RE: Deerhaven Generating Station
DEP Case Number PA 74-04
Amendment Request - Retrofit Project

RE: Gainesville Regional Utilities (GRU)
Deerhaven Generating Station (PA 74-04)
Retrofit Project – Process and Stormwater Configurations

City of Gainesville, Gainesville Regional Utilities
Deerhaven Unit 2
Air Quality Control Systems Retrofit/Turbine Upgrade Project
January 17, 2007

Proposed Additional Switchgear

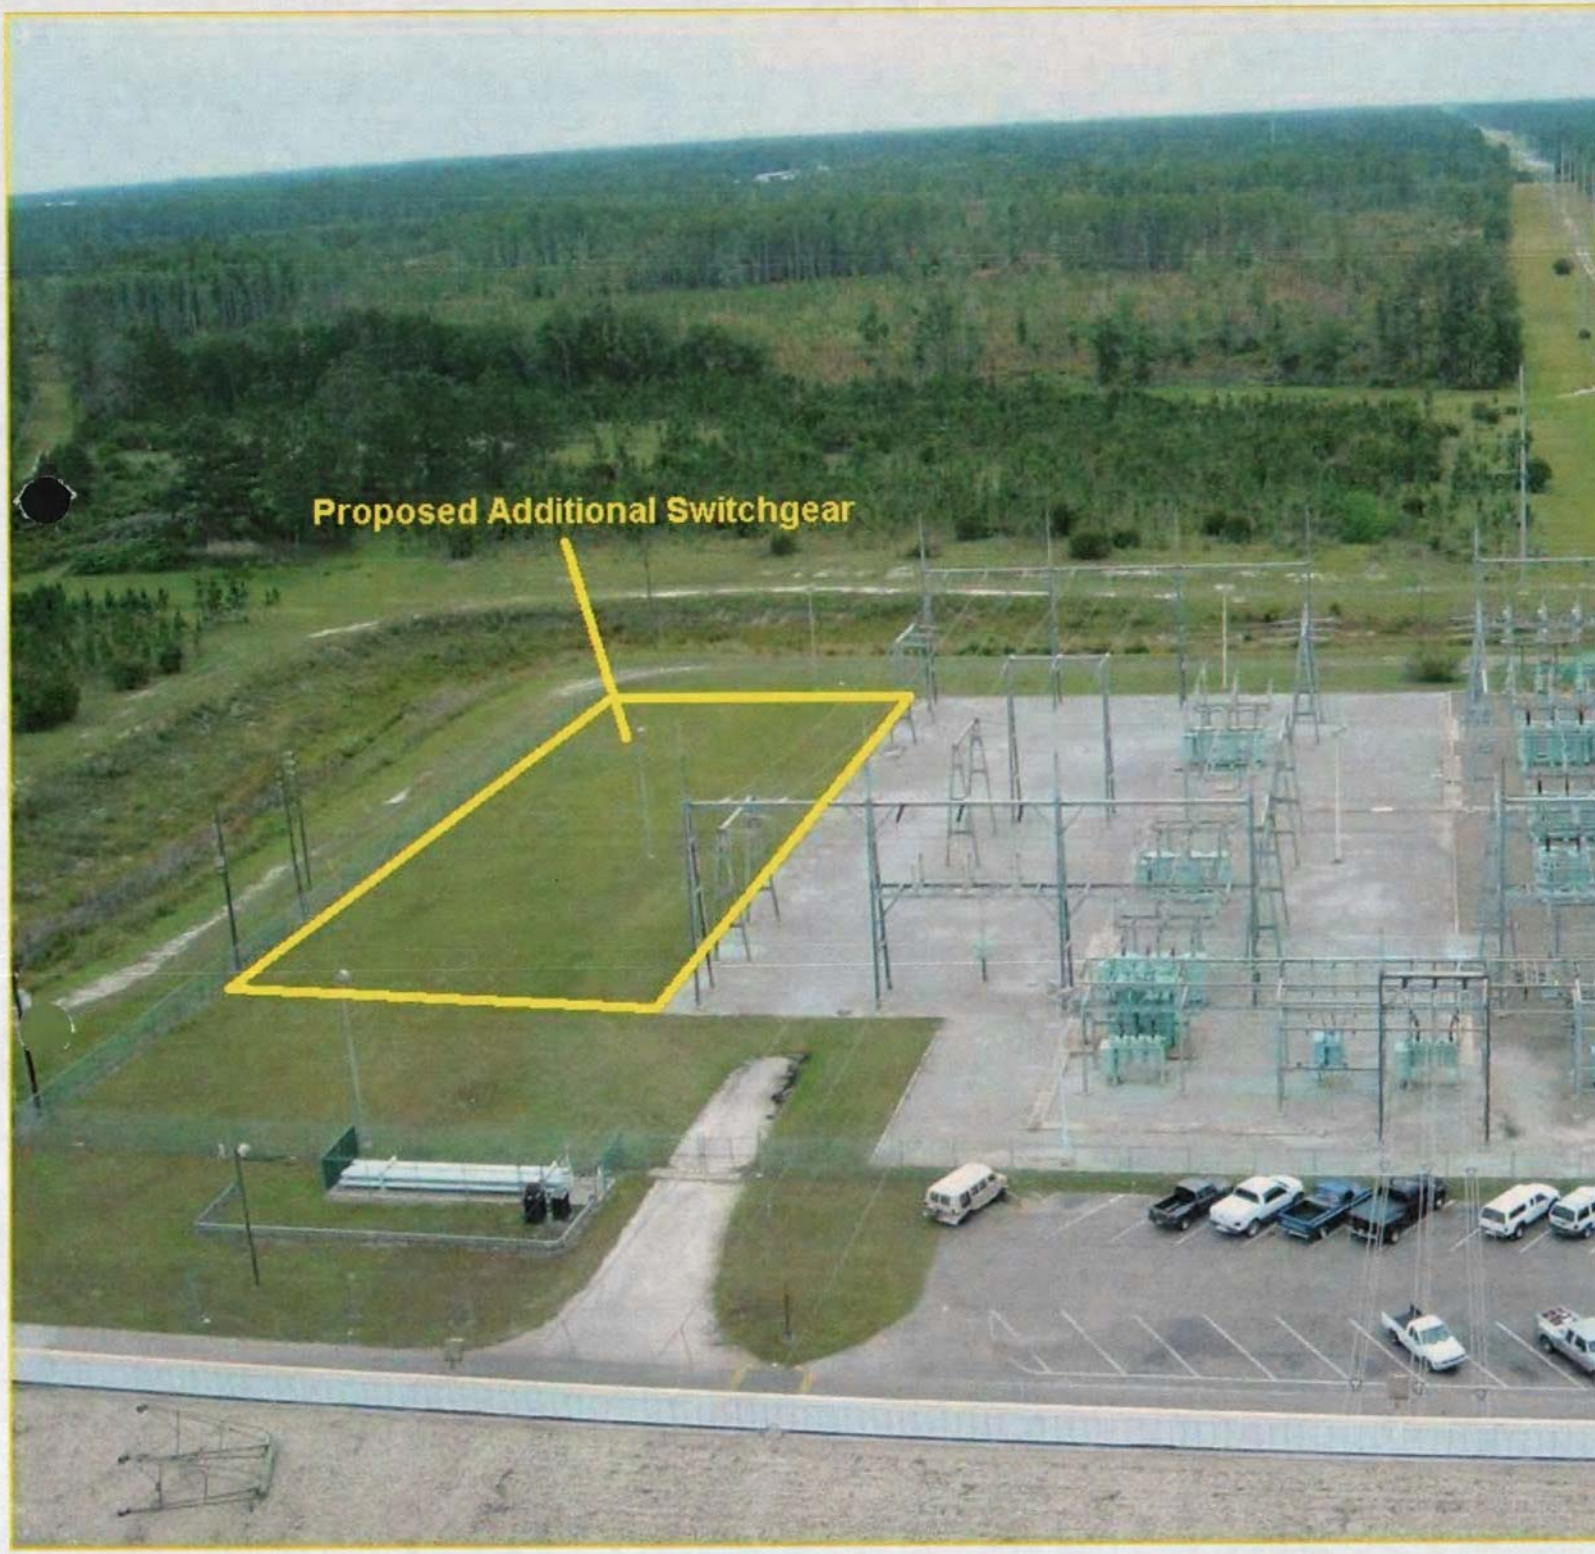
Energy Requirements: The new systems will require approximately 6-8 megawatts of auxiliary power. Additional electrical equipment will be added to the existing switchyard located on the south side of the plant to provide power to the AQCS and will include two (2) 10 MVA transformers with appropriate containment, two (2) manual disconnects, and two (2) circuit switches.
